HASTINGS HERITAGE PRESERVATION COMMISSION

Agenda for Meeting of September 17, 2024 Regular business at 7:00 p.m. at City Hall in the Volunteer Room

221 Sibley Street. Levi Hafstad, Hafstad Real Estate LLC– Replace windows Ca. 1881, East 2nd Street Historic District, National Register

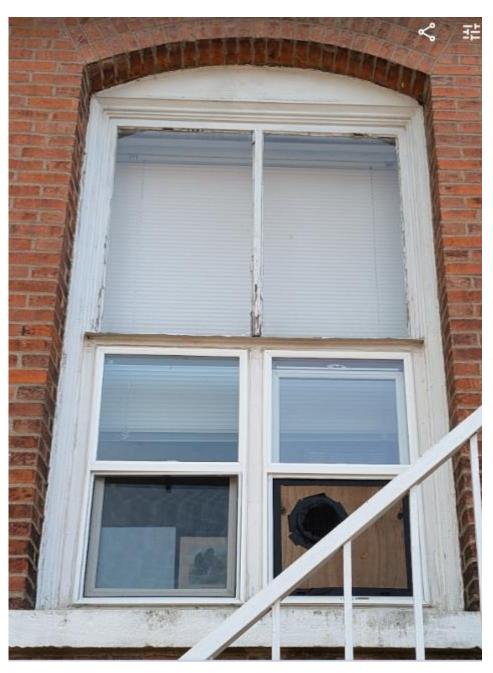
The second story windows are not historic and the HPC has acknowledged the appropriateness of replacing these windows with the proposed windows and storms.

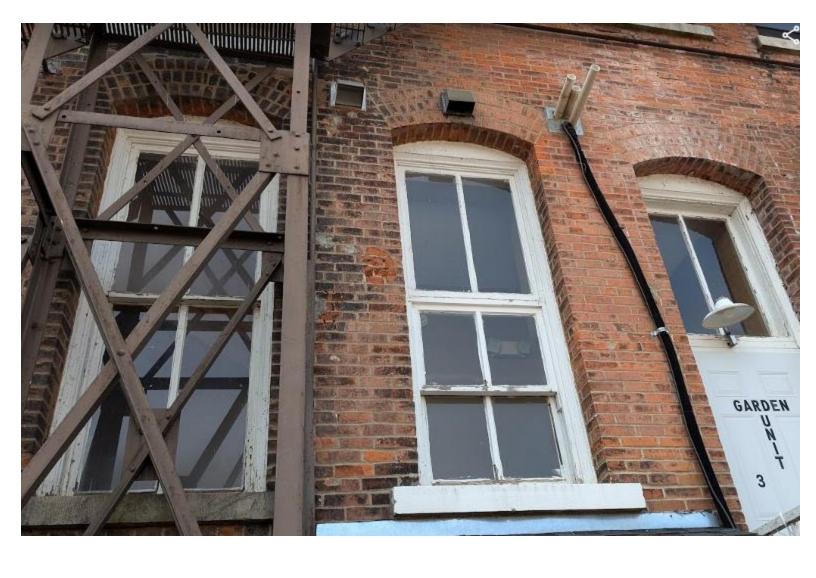
Repairing the window per the Design Guidelines is preferable. However, the center window is in poor condition and the left and right windows have been altered significantly. Replacement with a historically fitting replacement may be appropriate. They should include a 2 over 2 simulated divider like was conditioned on the previous historic replacement approved last year.

Approved and replaced, still needs center divider
